CITY OF FRANKLIN
PLAN COMMISSION MEETING*
FRANKLIN CITY HALL COUNCIL CHAMBERS
9229 W. LOOMIS ROAD, FRANKLIN, WISCONSIN
AGENDA
THURSDAY, OCTOBER 8, 2020, 7:00 P.M.

REPORT TO THE PLAN COMMISSION

Special Use and Site Plan

RECOMMENDATION: City Development staff recommends approval of the proposed Special Use and associated Site Plan for Strauss Brands meat processing facility upon property located on Lot 83 of Ryan Meadows subject to the conditions set forth in the draft Resolution.

PROPOSED BUILDING
 152,035 SF | FFE= 811.00
 SEE ARCHITECTURAL PLANS FOR ADDITIONAL INFORMATION

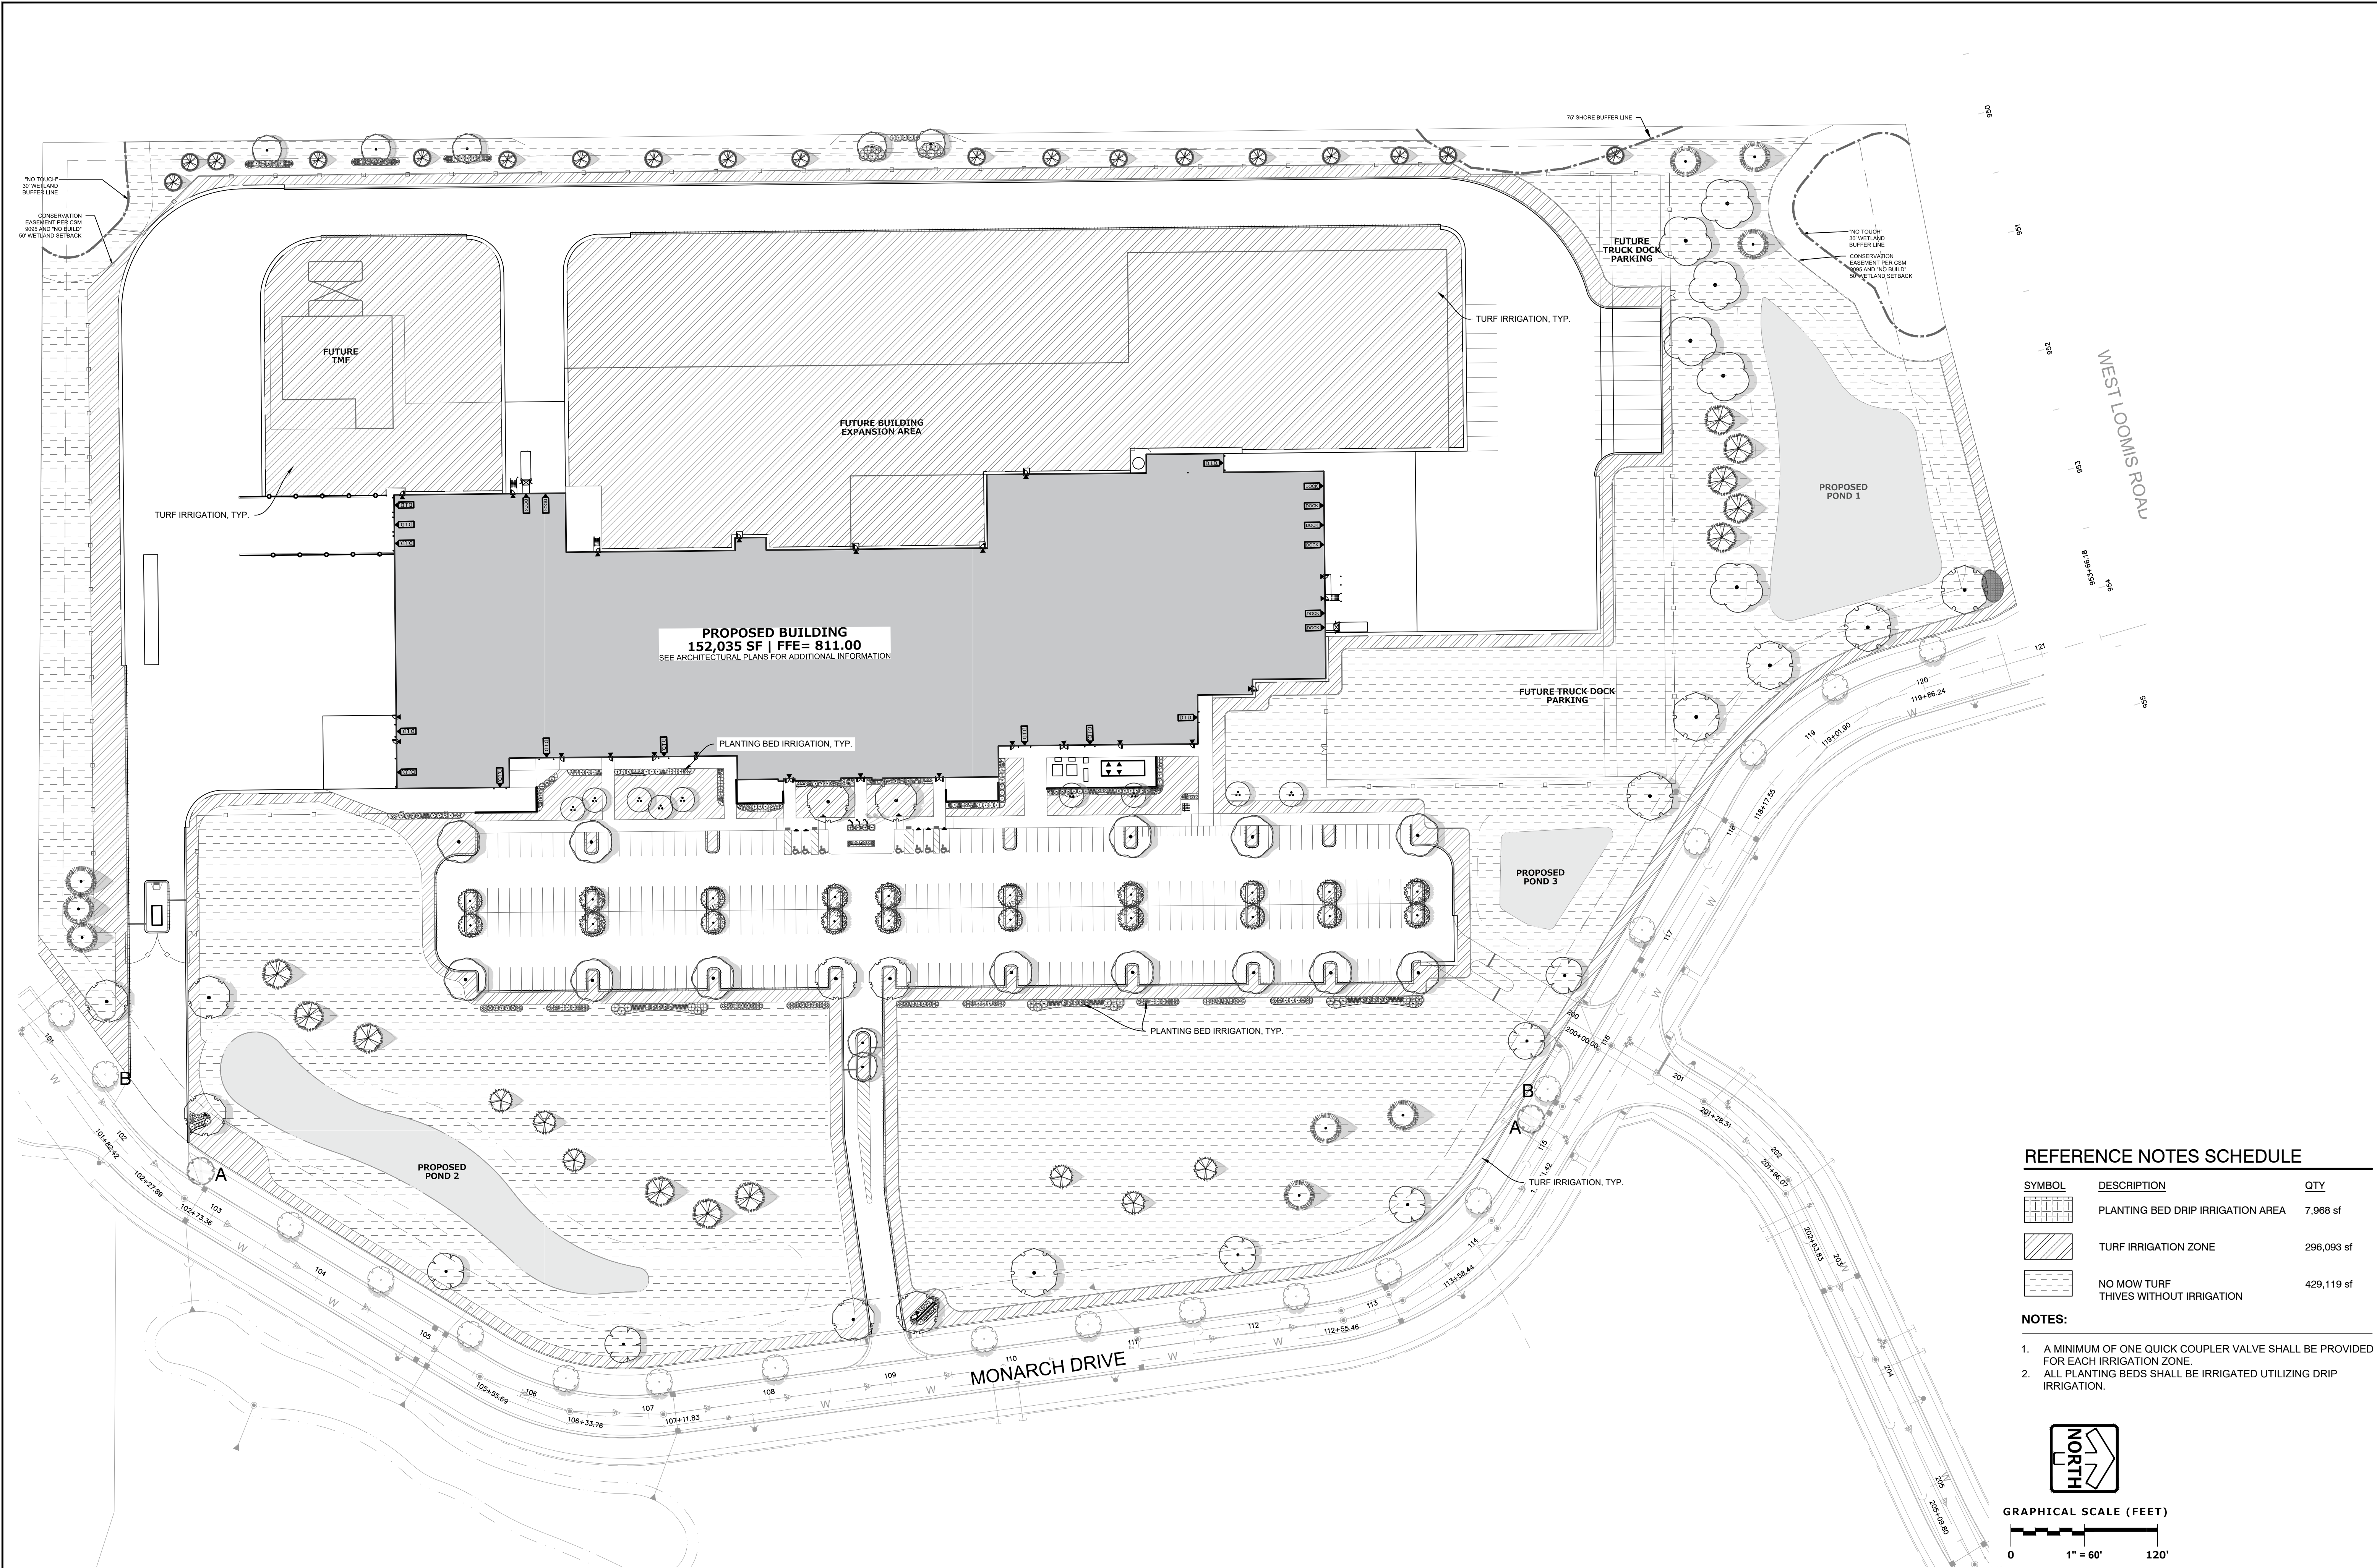
2. Pursuant to UDO §15-5.0210, the minimum snow storage area is 10% of the total pavement areas (391,687 sf per site data table in sheet C300). Please revise the snow storage plan (sheet L401) to meet this requirement.

Response: *Drawing L401 has been updated to show the required snow storage.*
